October 3, 2018

Re: Objections to the Inyo National Forest Plan Revision and Species of Conservation Concern

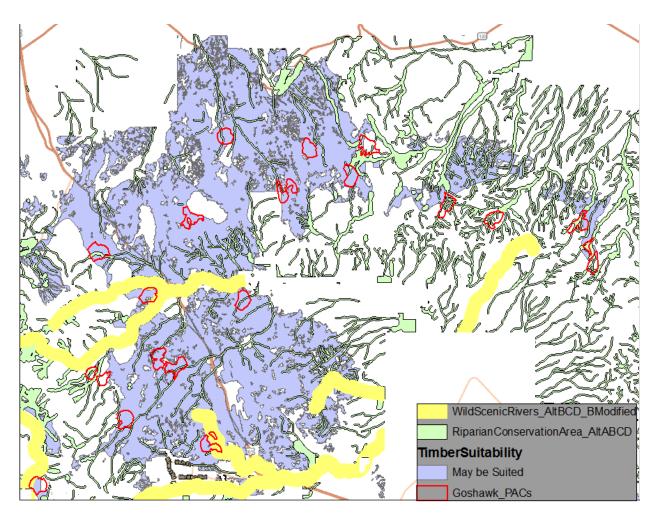
It is especially concerning that the SCC Rationale fails to mention how current forest plan direction, which protects from thinning 80 ha (200 acres) of the highest quality nesting habitat surrounding each goshawk nest, is no longer necessary. The protection of 80 ha of the highest quality nesting and roosting habitat associated with each goshawk nest was specifically developed to minimize reductions in canopy cover, a key ecological condition on which the species depends, from forest thinning practices.

It is our experience that the vast majority of "restoration based" thinning projects reduce canopy cover to levels that would not support goshawk nesting and the desired conditions for the forest types goshawks depend on in the revised forest plan do not ensure that adequate amounts of high canopy cover forests will exist in areas where "restoration based" thinning occurs. For example, the desired conditions in the revised plan (Table 1, p. 18) suggest that it may be desirable to have no dense mature Jeffrey pine, no dense mature dry mixed conifer, and as little as 10% dense mature red fir forest across the plan area. At this time, many goshawk nests occur in Jeffrey pine and dry mixed conifer forests in the plan area and the desired conditions for these vegetation types do not ensure that any mature dense forest habitat will be provided. In other words, the desired conditions for the forest types on which the species depends allows for management to create conditions that do not support the ecological conditions on which the species depends as part of forest restoration thinning.

A reoccurring theme for revising the Inyo forest plan is that forests in the plan area are too dense, and therefore must be thinned to minimize the threats of wildfire and climate-related tree mortality. Even in the red fir forest type, where it is desired to have at least 10% of the forest type composed of mature dense forest, there is no mechanism in the revised plan to ensure that large enough contiguous blocks (i.e., 80 ha) of mature dense forest habitat will be provided anywhere on the landscape in areas that undergo restoration-based thinning. Based on an analysis of current goshawk protected activity centers vs. timber suitability (Figure 1), 14 of the 38 (37%) goshawk protected activity centers have considerable overlap with areas designated as suitable for timber. The revised plan does not include any plan components for retaining canopy cover at levels that would support goshawk nesting. Clearly, forest "restoration based" thinning represents a threat to a key ecological condition on which the species depends (i.e., mature dense forests) and the forest plan provides no assurances that this necessary ecological condition will be provided in the plan area.

<u>Suggested resolution</u>: As a result of ongoing and increasing threats to the species from high severity wildfire, climate-related tree mortality, and "restoration based" thinning on mature closed canopy cover forest habitat in the plan area, the Forest Service should include the northern goshawk as a Species of Conservation Concern and the revised forest plan should be modified to reinstate the protection of 80 ha of nesting habitat associated with each northern goshawk nest identified.
